ADDENDUM NO. 1

WASHINGTON STATE PARKS AND RECREATION COMMISSION
ILLAHEE STATE PARK
WELCOME STATION AND ENTRANCE ROAD
SW-C1701

DATE: SEPTEMBER 06, 2024

TYP. UTILITY TRENCH
A
NTS

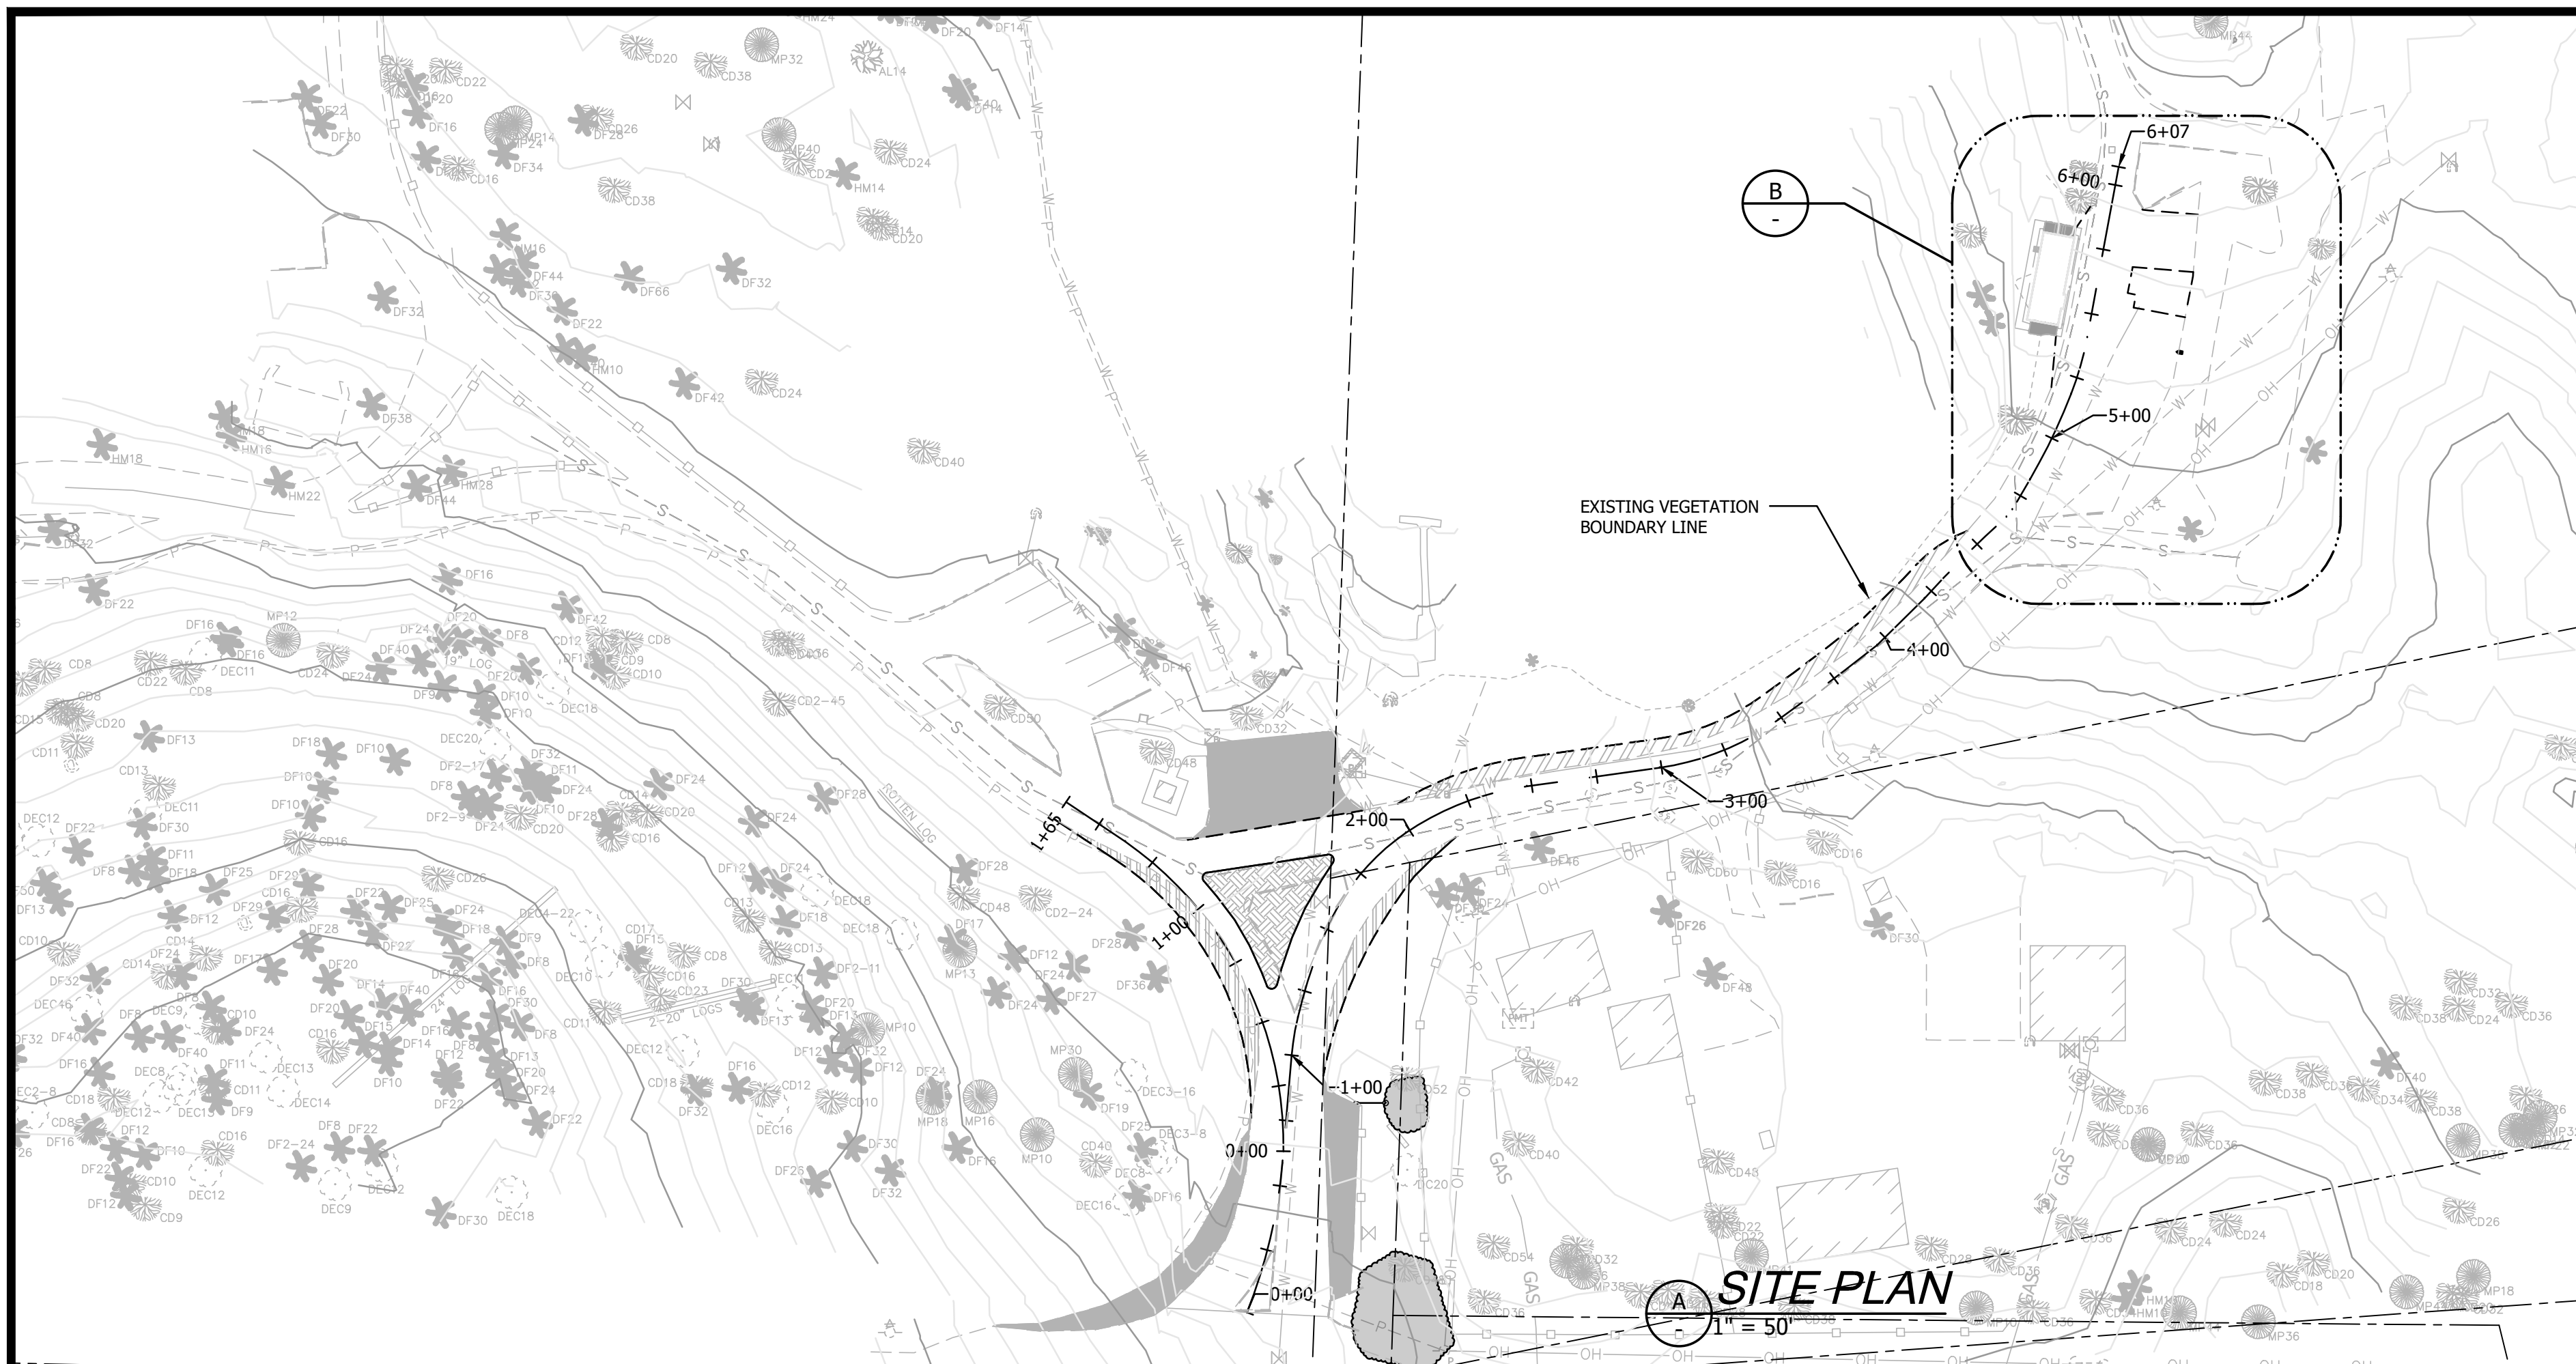
ADD Sheet “ADDENDUM #1 5.4. This sheet has a standard trench detail.

- A. PROVIDE 18" MINIMUM BURIAL DEPTH FOR NONMETALLIC WATER SUPPLY, SEWER LINES, ELECTRICAL CONDUITS.
- A.1. PROVIDE 18" MINIMUM VERTICAL SEPARATION WHERE WATER, SEWER LINES CROSS ELECTRICAL CONDUIT.
- A.2. PROVIDE SLEEVING WHERE 10' HORIZONTAL SEPARATION BETWEEN WATER, SEWER LINES CANNOT BE MAINTAINED. SLEEVING MUST EXTEND 10' BEYOND POINT WHERE MINIMUM SEPARATION CANNOT BE MAINTAINED.

SITE PLAN PROPOSED w/ CONTOURS

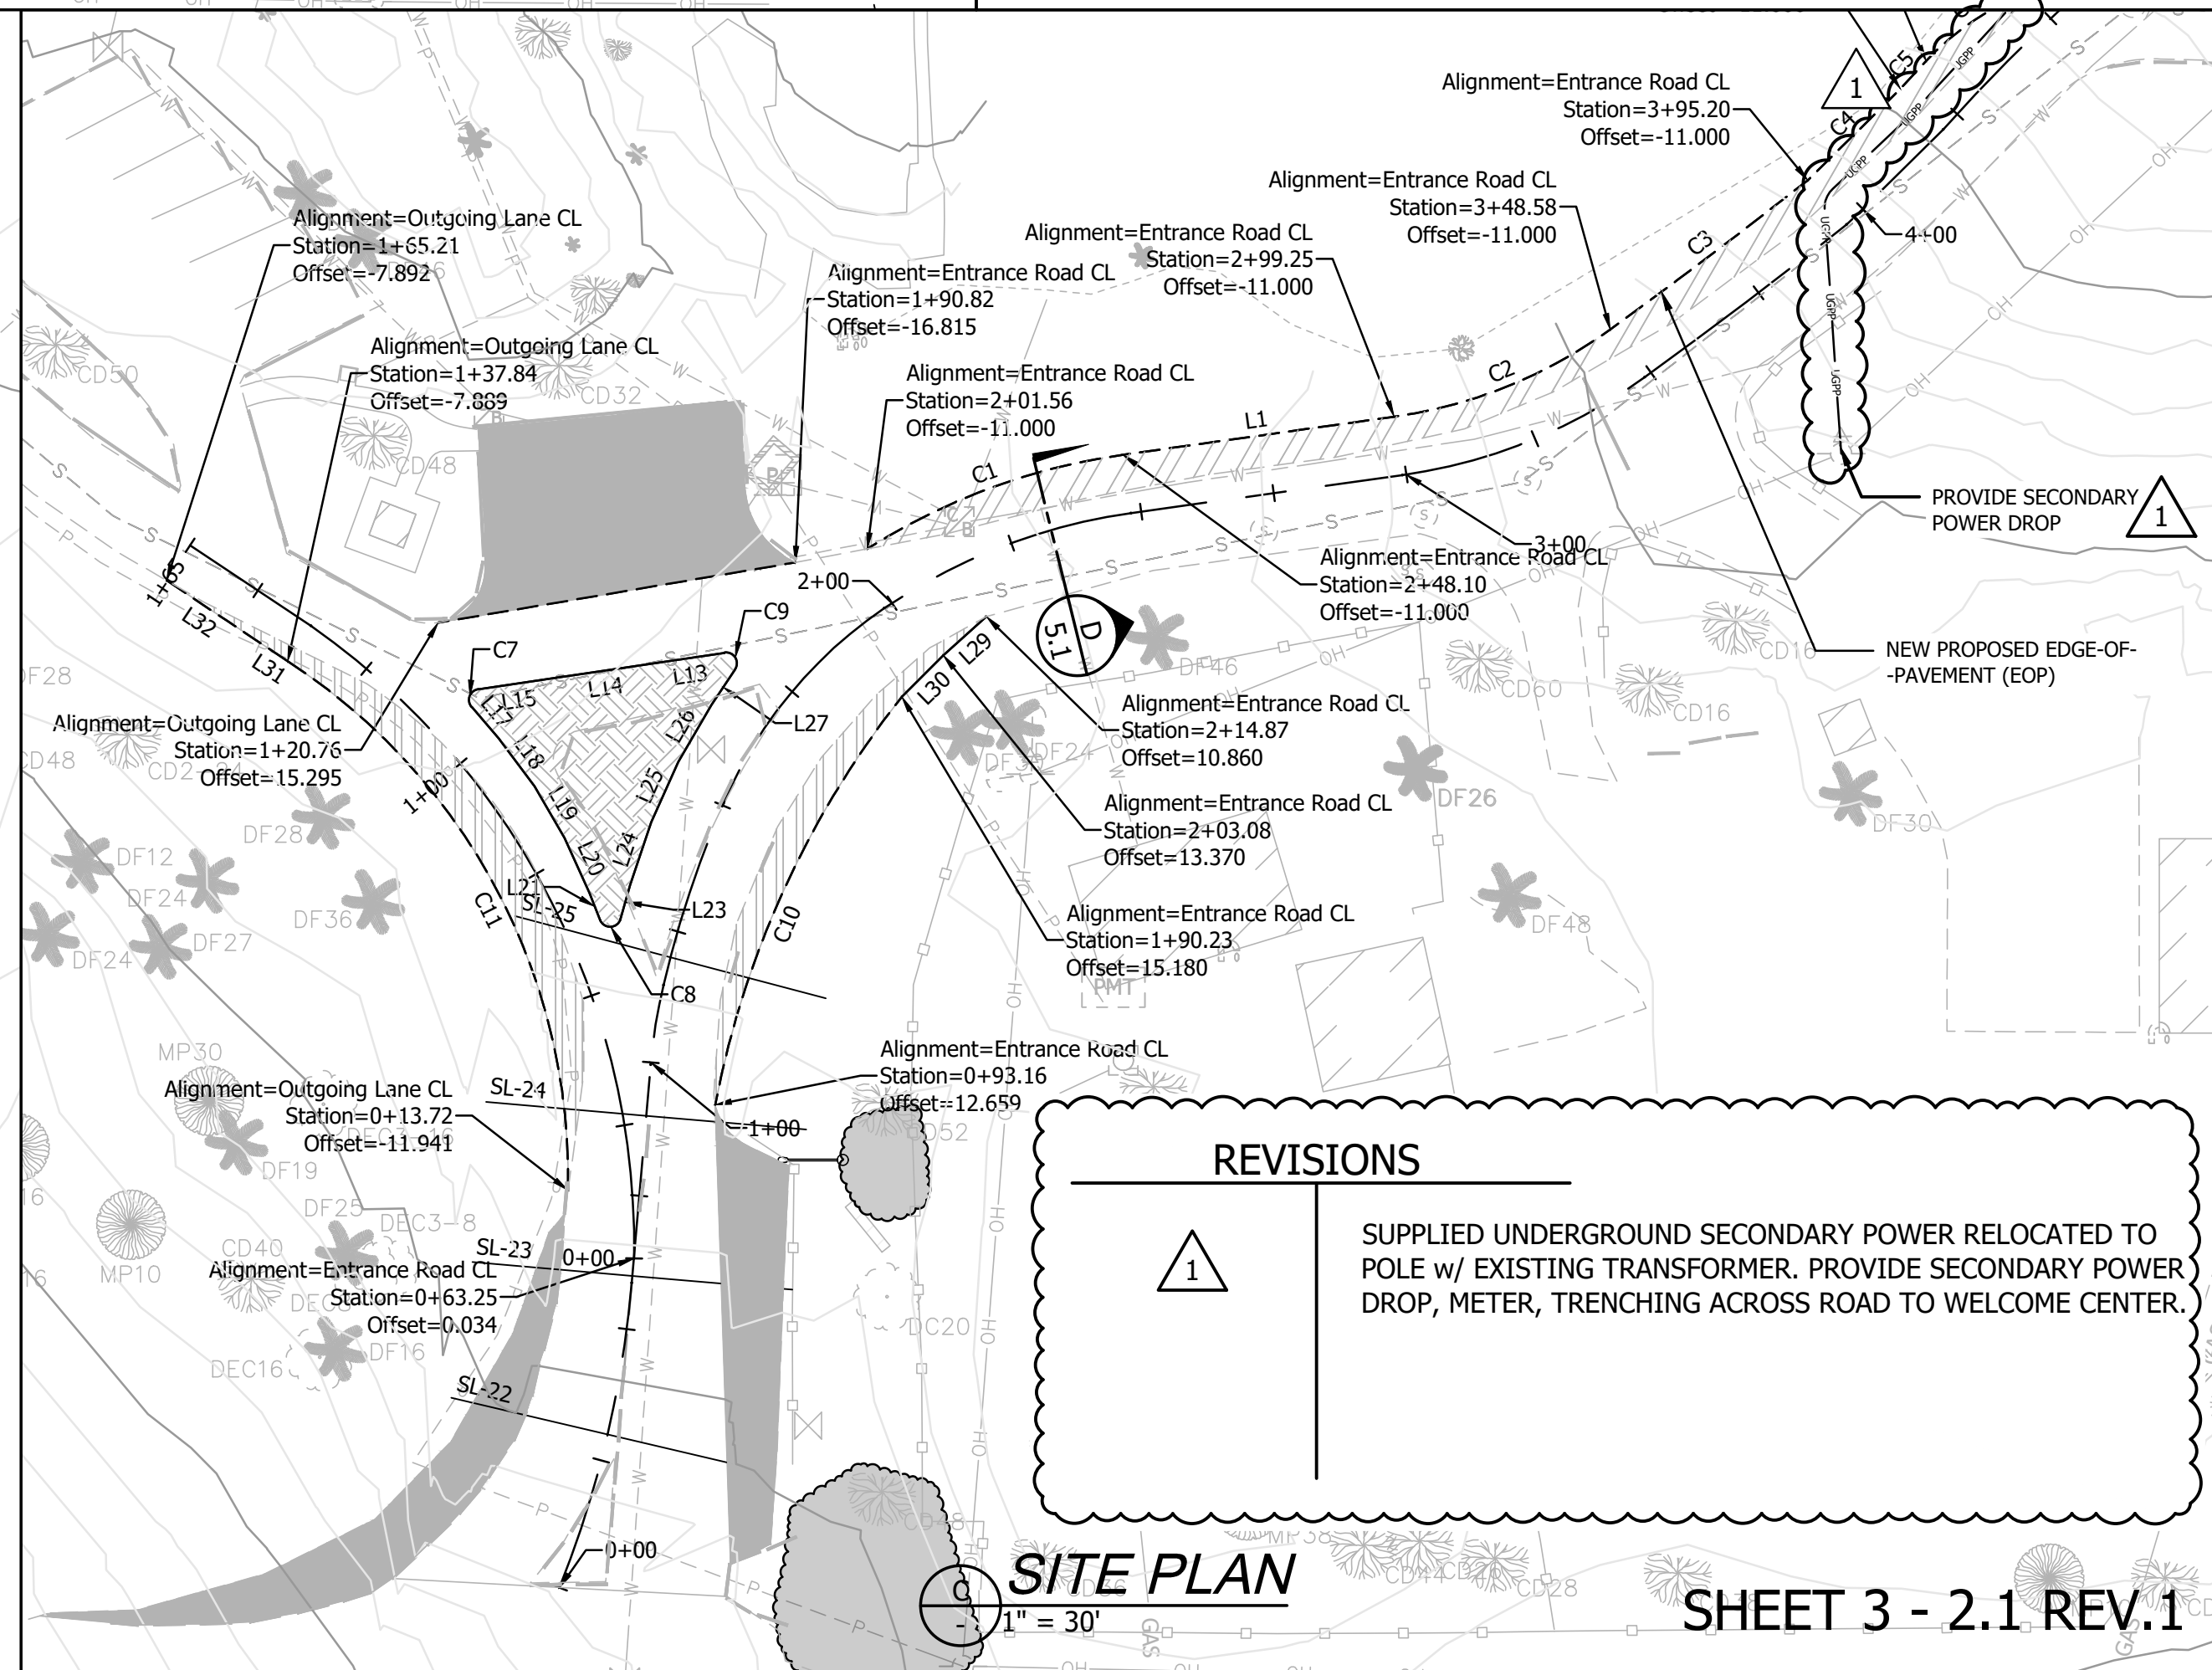
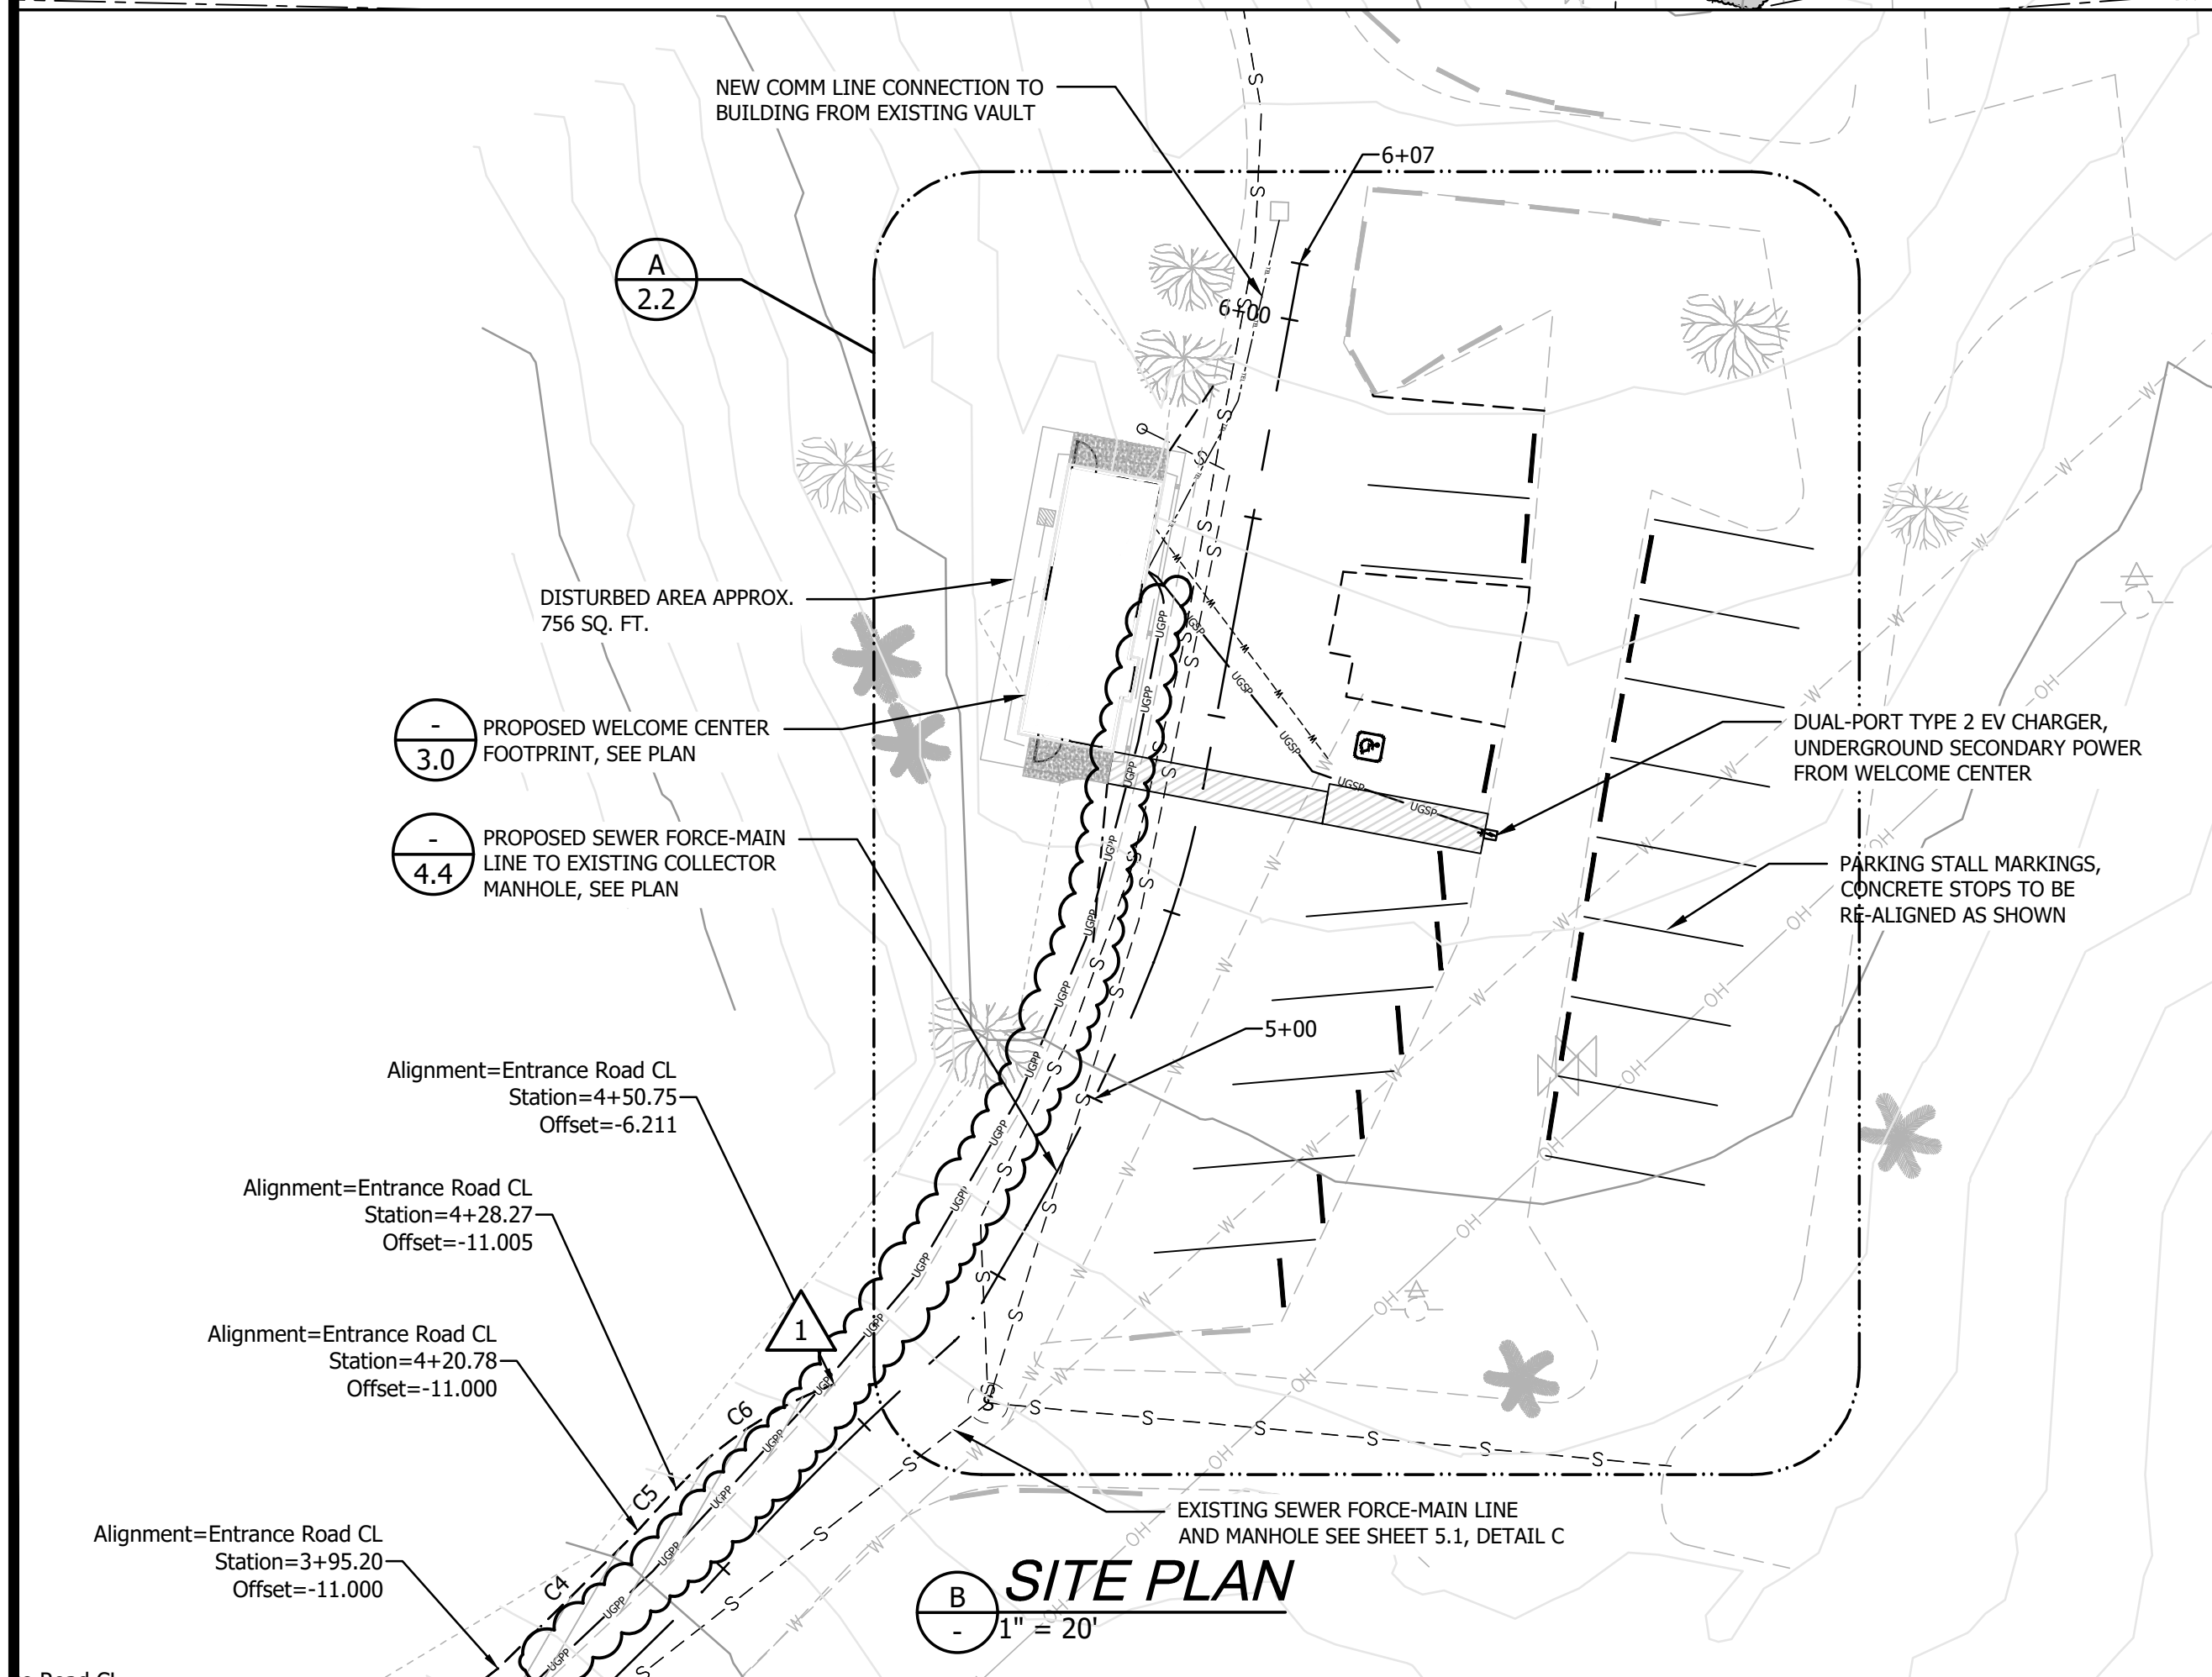
Remove “SHEET 3 – 2.1: SITE PLAN PROPOSED w/CONTOURS” and replace with “SHEET 3 -2.1 REV 1 SITE PLAN PROPOSED w/CONTOURS” The new plan identifies a new location for the secondary power connection.

1 SUPPLIED UNDERGROUND SECONDARY POWER RELOCATED TO POLE w/ EXISTING TRANSFORMER. PROVIDE SECONDARY POWER DROP, METER, TRENCHING ACROSS ROAD TO WELCOME CENTER.
